PROJECT NUMBER: SP2023-042  
PROJECT NAME: Amended Site Plan for 1007 Ridge Road  
SITE ADDRESS/LOCATIONS: 1007 RIDGE RD

CASE CAPTION: Discuss and consider a request by Kamran Khan for the approval of an Amended Site Plan for an existing general retail building on a 0.55-acre parcel of land identified as Lot 1, Block A, Burgamy Addition, City of Rockwall, Rockwall County, Texas, zoned Commercial (C) District, situated within the Scenic Overlay (SOV) District, addressed as 1007 Ridge Road, and take any action necessary.

11/20/2023: SP2023-042: Amended Site Plan for an Existing General Retail Building  
Please address the following comments (M= Mandatory Comments; I = Informational Comments)

EXISTING FRONT ELEVATION

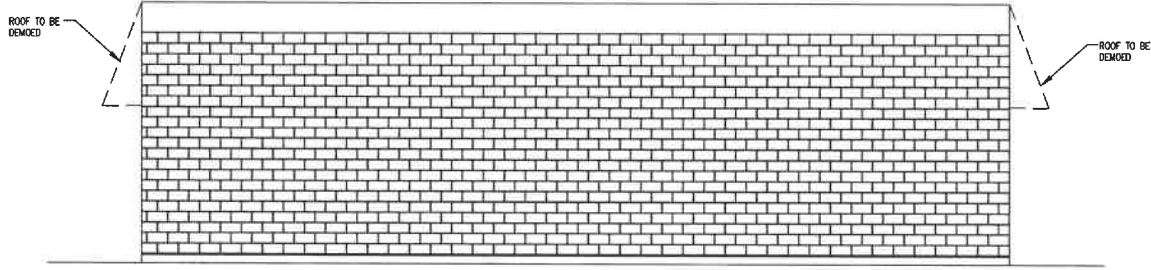
If anything on site is changing/relocating, full site plan required.

DUMPSTER ENCLOSURE SIDE ELEVATION

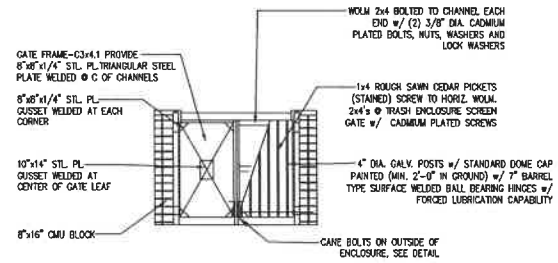
Need overall site plan showing dumpster area

Need to show oil/water separator for dumpster area. Must drain to the storm system...not the sanitary sewer

SHEET  
 A3.01

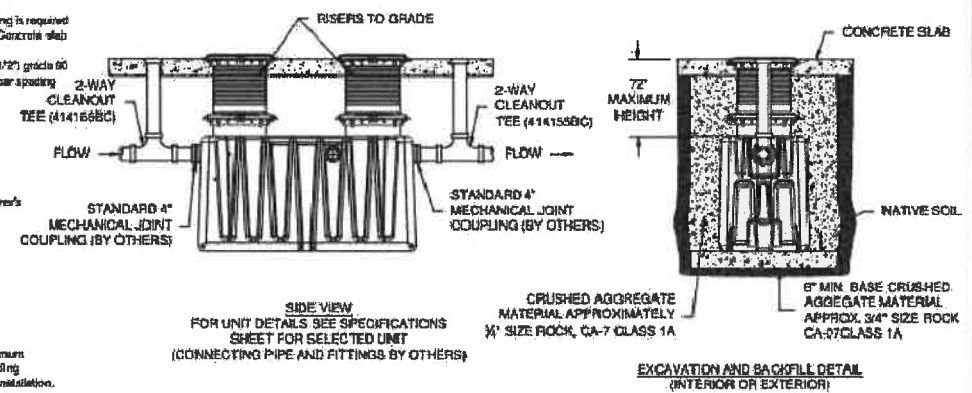
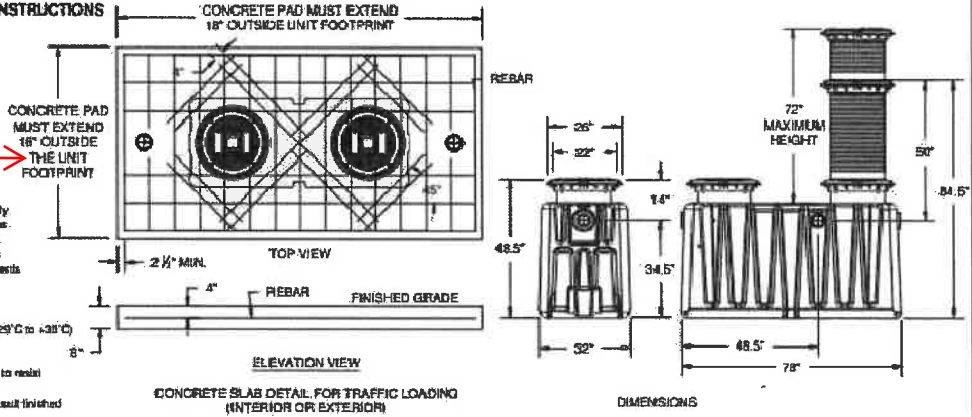
This will need to be shown on the site plan.
